RE: Phased Subdivision Application for 6719 Devon Avenue SE (AMANDA 20-118048-LD)

PW Completeness Review_Civil Plans_Devon Estates.pdf Markup Summary

P407

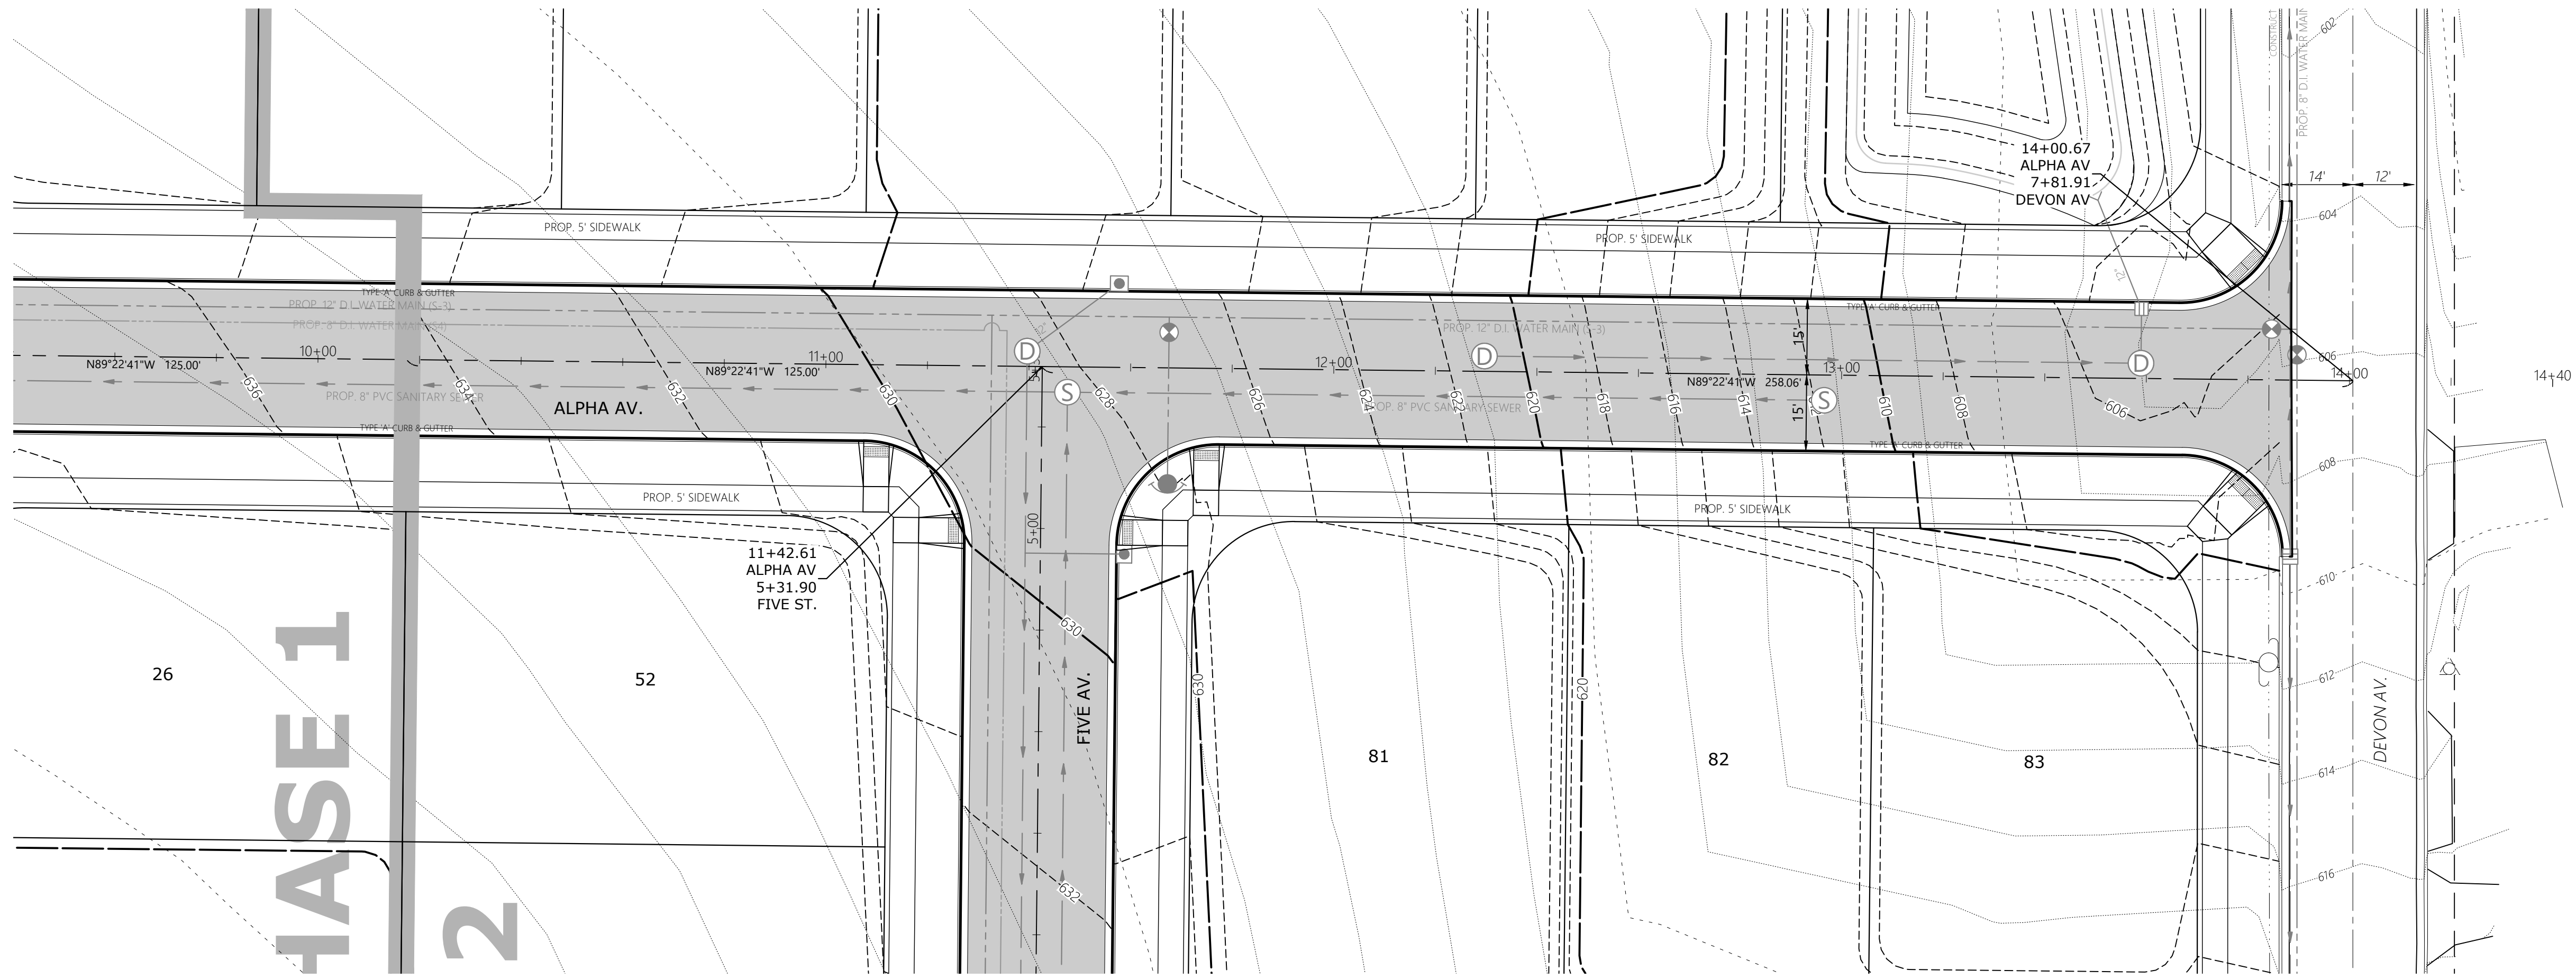
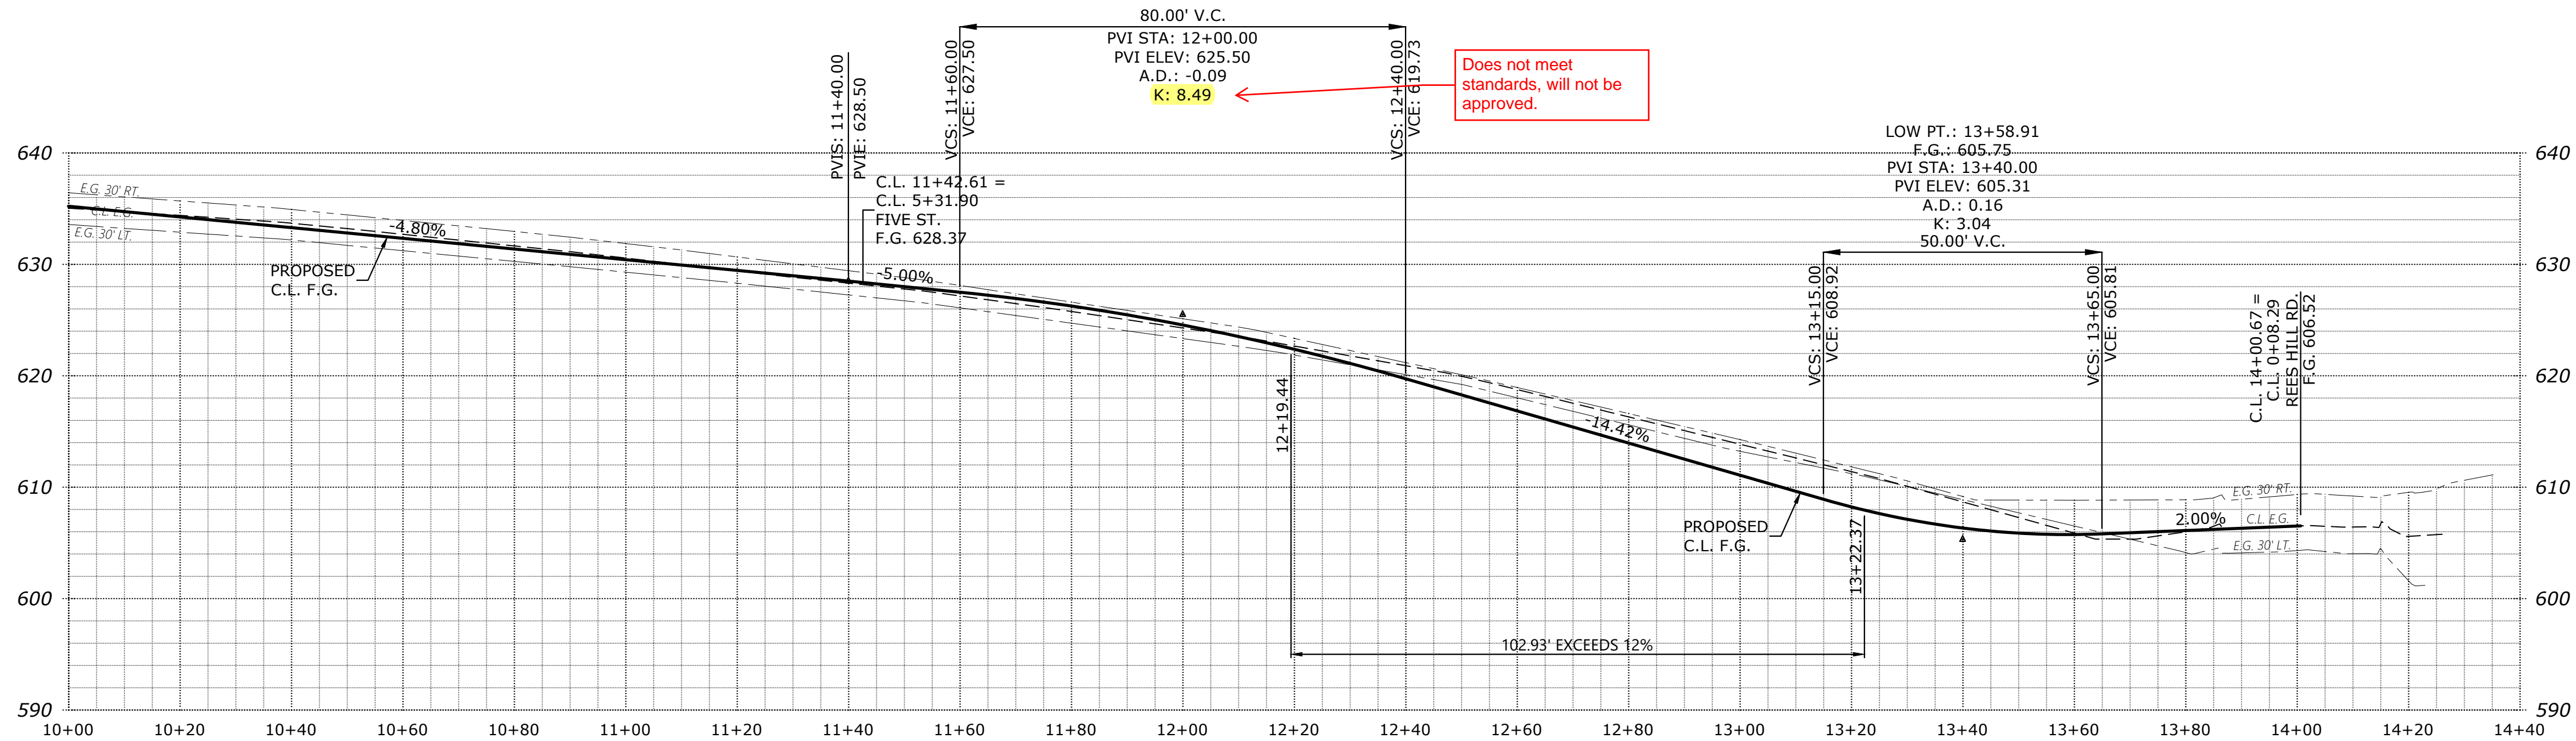
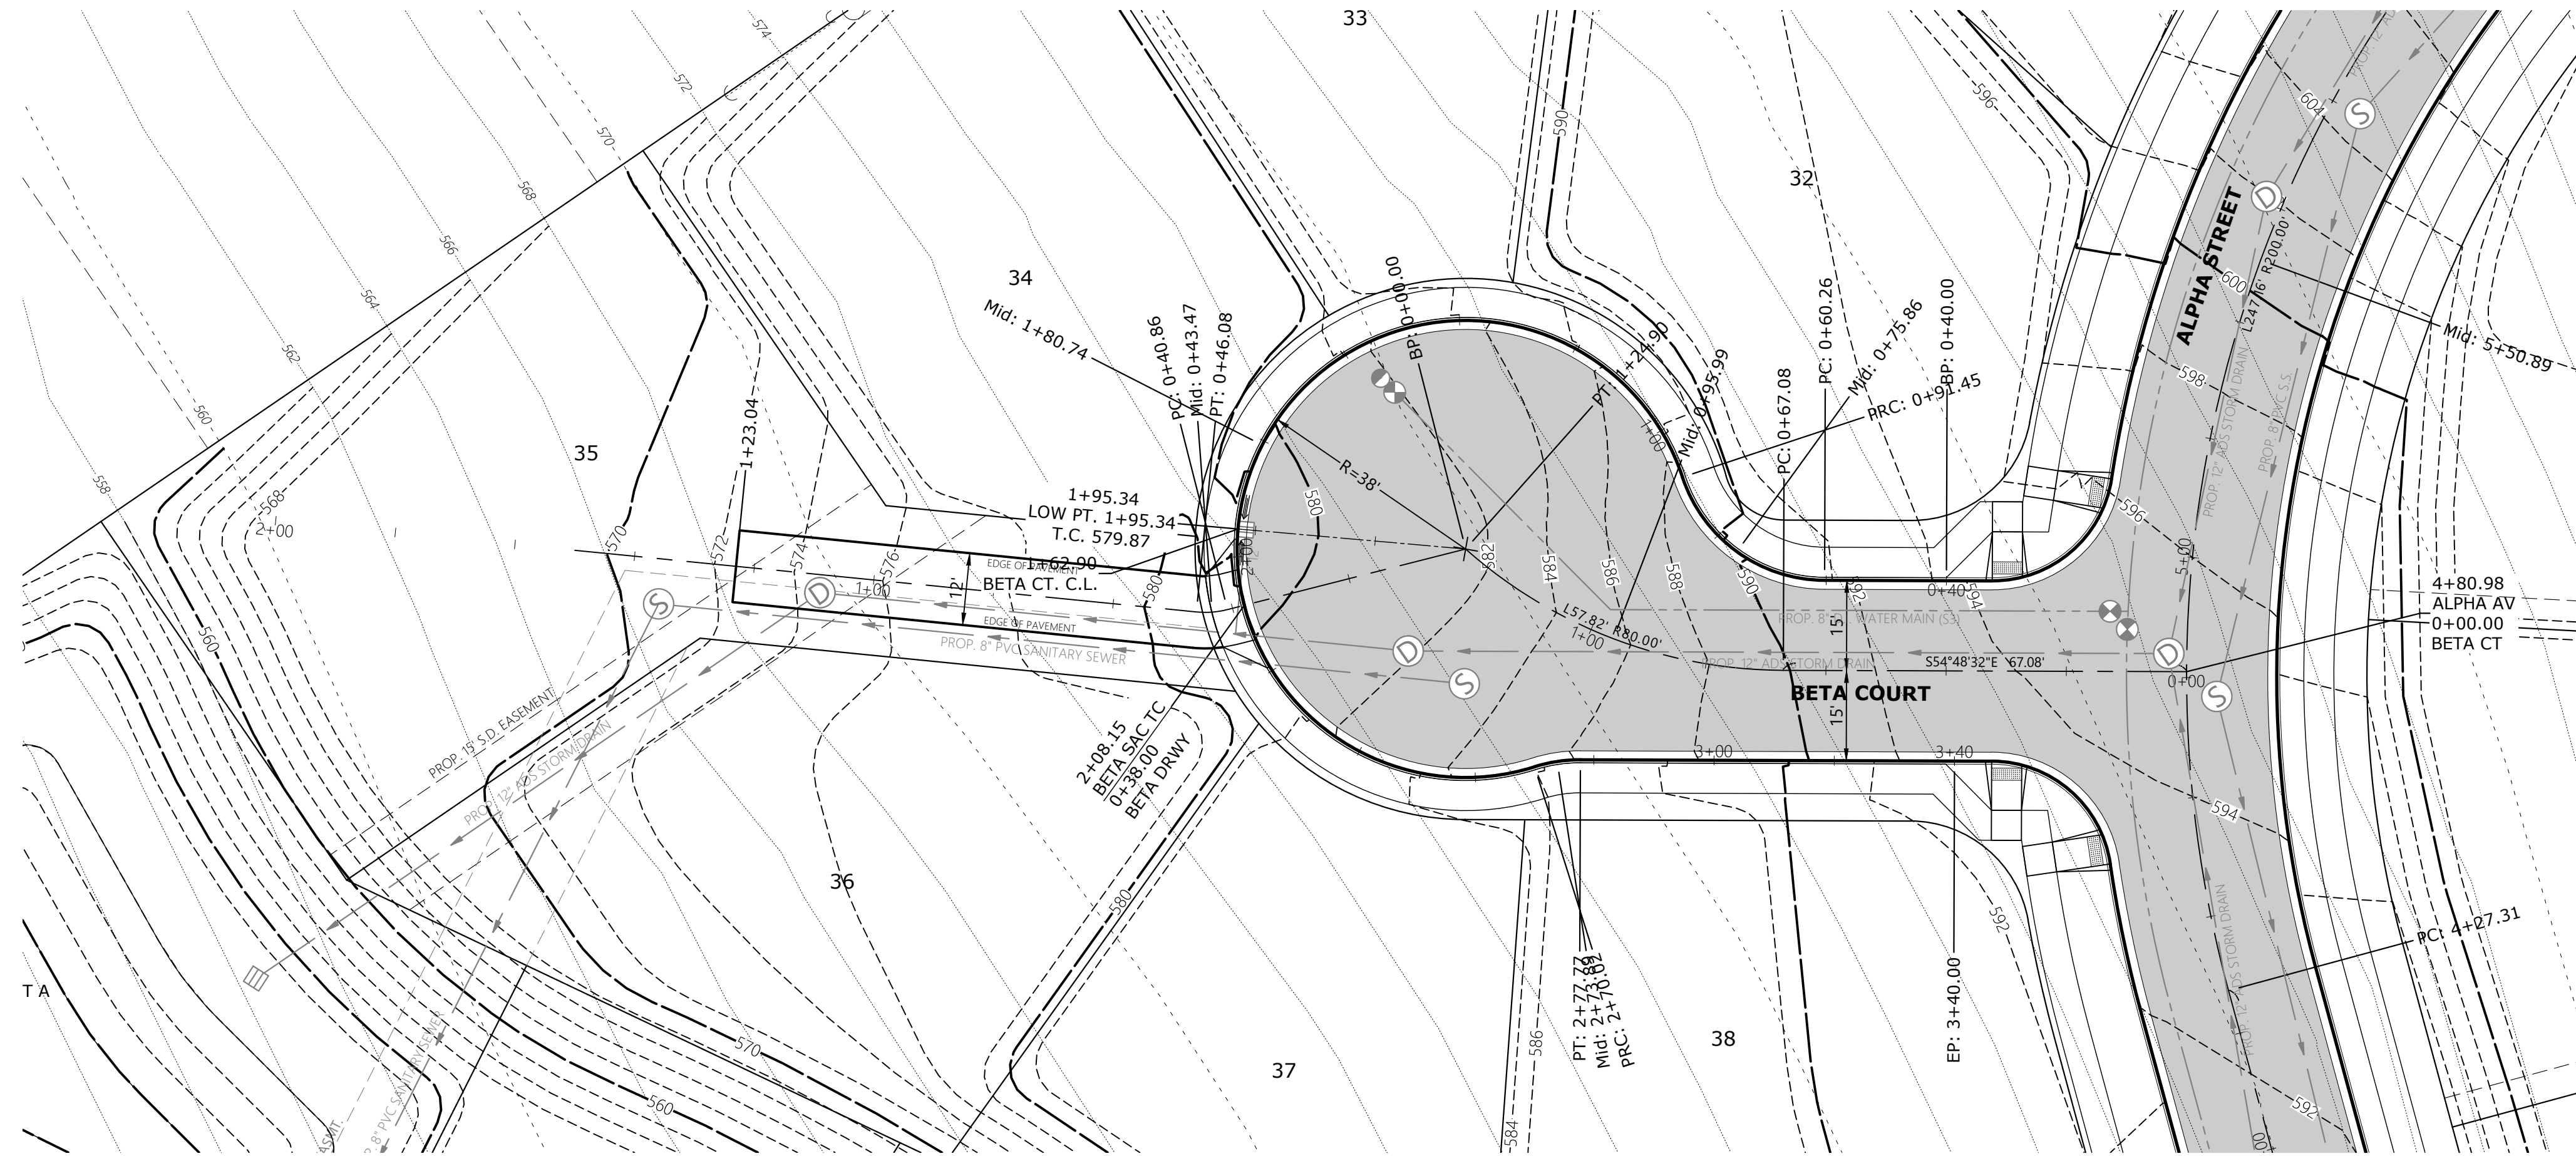
Does not meet standards, will not be approved.
